GRPE Working Group on VIAQ –  
Evaluation of test procedure  
“Draft Part IV of the Mutual Resolution (M.R.3) on Vehicle  
Interior Air Quality,,

Measurements and recommendations by OICA.  
May, 25th, 2023

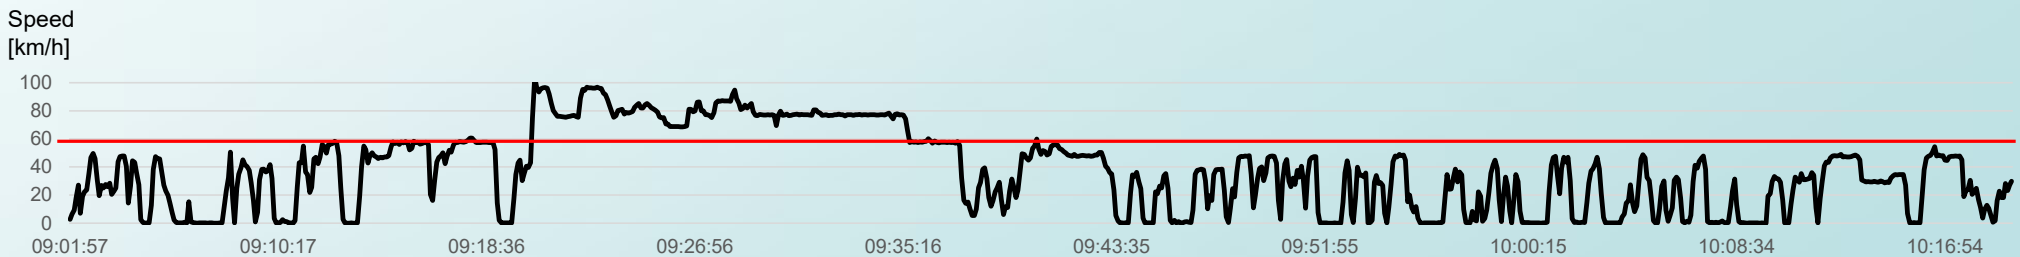
→ Urban traffic percentage limit exceeded, measurement time limit exceeded

VIAQ measurement PM 2.5 / CO<sub>2</sub> 01.02.2023

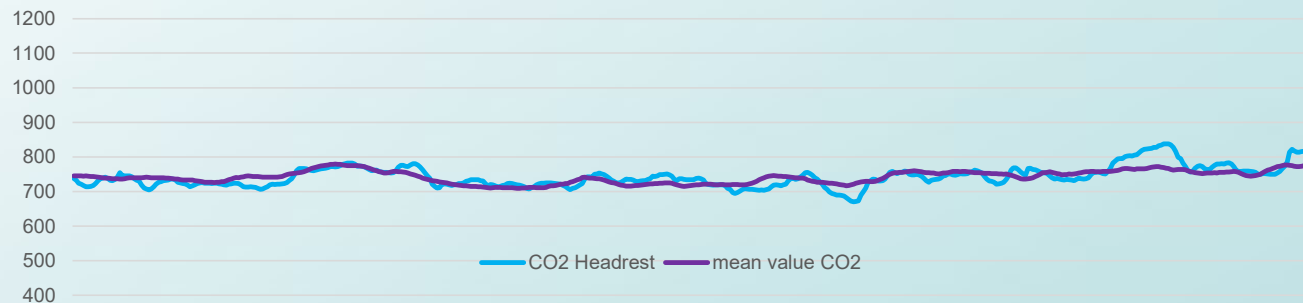
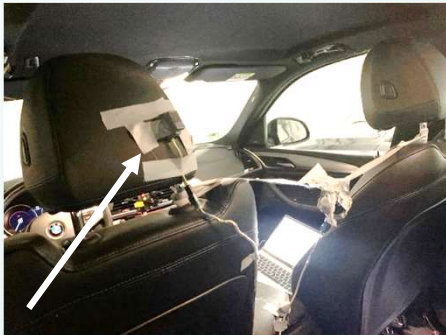
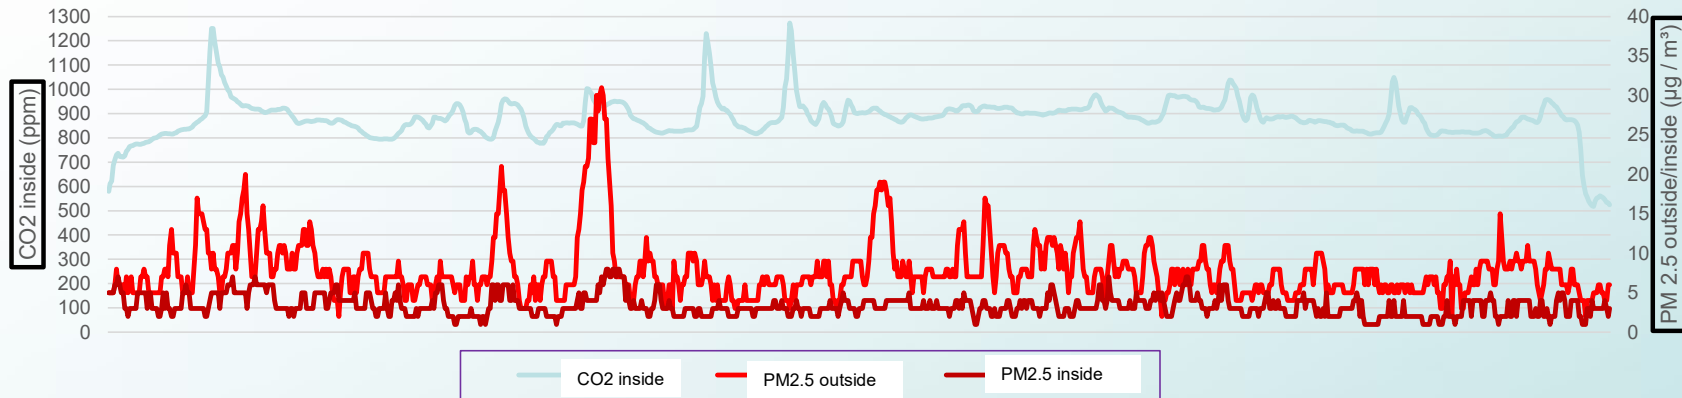
- several CO<sub>2</sub> peaks @ between headrest sensor, probably from exhalation.
- Average of 4 CO<sub>2</sub> sensors without significant peaks
- outside PM 2.5 usually < 30 µg/m<sup>3</sup>

- CO<sub>2</sub>-Sensor between headrests may be affected by breath of the driver or passenger → position behind driver headrest recommended
- Wind speed will influence outside conditions → maximum wind speed limit should be determined (e.g. 5 m/s)
- NO<sub>x</sub> measuring equipment often needs to be placed in trunk → sampling line length > 1 m necessary
- PM 2.5 concentration of > 30 µg/m<sup>3</sup> usually not present in most areas → reduction to e.g. 10 µg/m<sup>3</sup> (new WHO guideline)
- High speed of 60-100 km/h for 35-55% of test cycle in 1h is difficult to achieve, when you start track in cities → reduce high speed contribution to 10-20%
- Definition of urban speed should be changed to  $v < 50$  km/h (50 km/h city speed limit)
- Change measurement interval to 5 sec

VIAQ measurement NO, NO2 01.02.2023

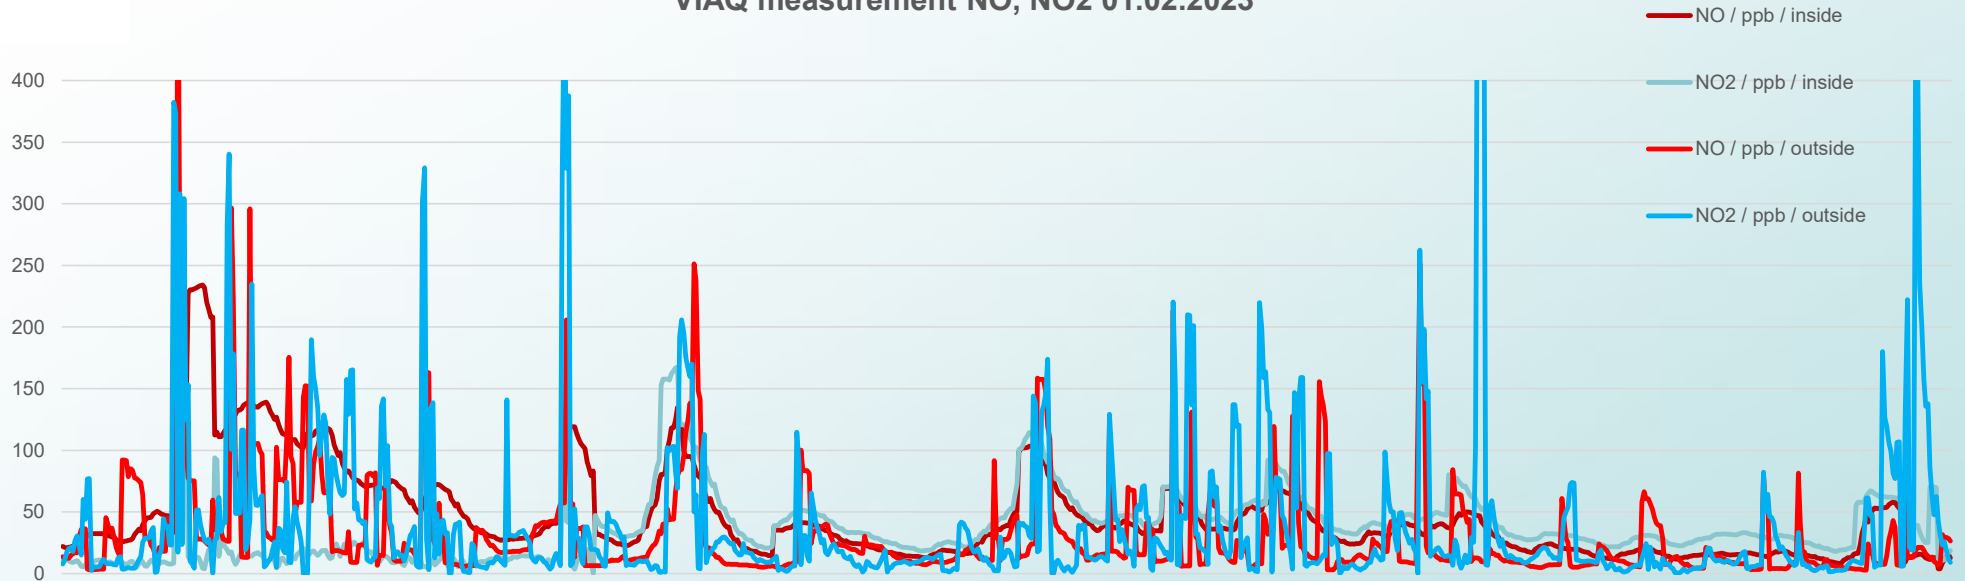
→ NO2 and NO outside mean around 30 ppb, peaks behind truck/old cars up to 500 ppb
